Inspection of Automatic Sprinkler System

East London Industrial Development -
Also - HS1

UNC.9499

Photo 6

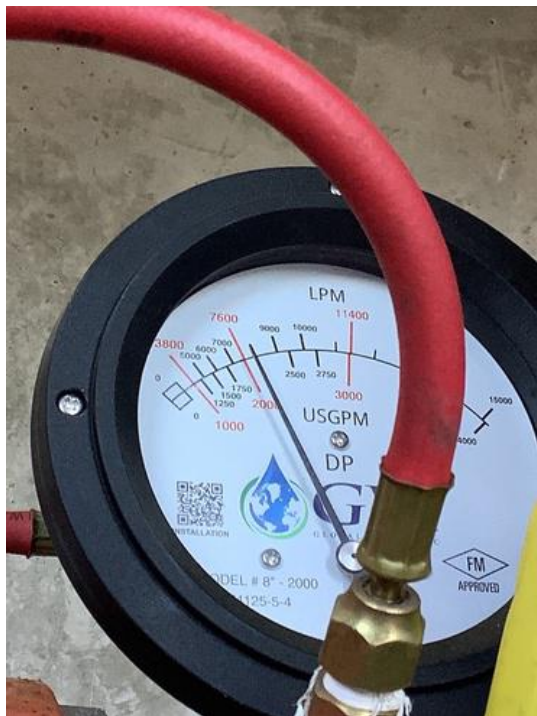
The flow switch must be fitted downstream from the alarm valve with a 25mm test pipe installed at least 2 pipe diameters downstream of the flow switch.

Photo 14

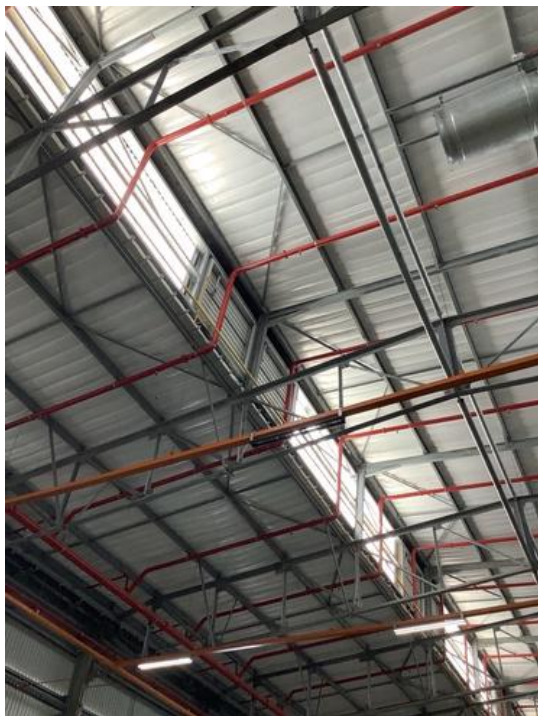
Ventilation has been installed in conjunction with ESFR sprinkler protection.

It is imperative that the mechanical vents do not open automatically in a fire situation as the ESFR sprinkler system will be adversely effected which could result in the ESFR system failure.

It is important that the mechanical vents be manually operated and that the Fire Chief in charge of operations during a fire be able to make the decision whether it should be opened or remain closed.

Photo 17

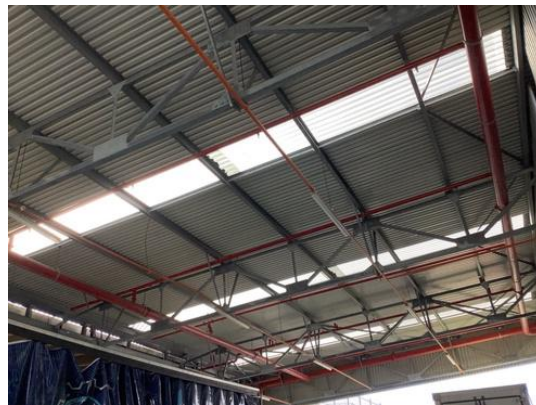
The sprinkler pipe work must be correctly supported.

Distribution rise/drop pipes shall be secured directly to the building structure or by hangers securing horizontal distribution pipes within 300 mm of the riser.

Photo 19

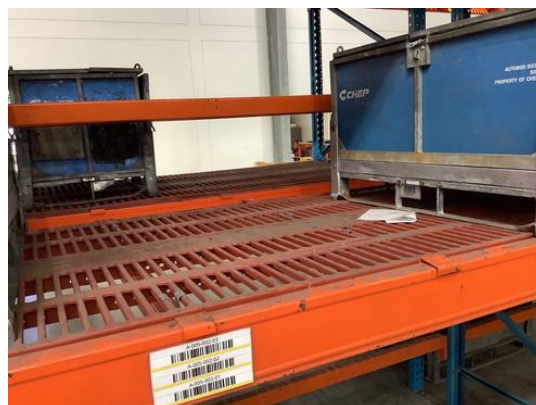
Terminal hangers on distribution pipes are exceeding the maximum distance of 450 mm from the end of the distribution pipe.
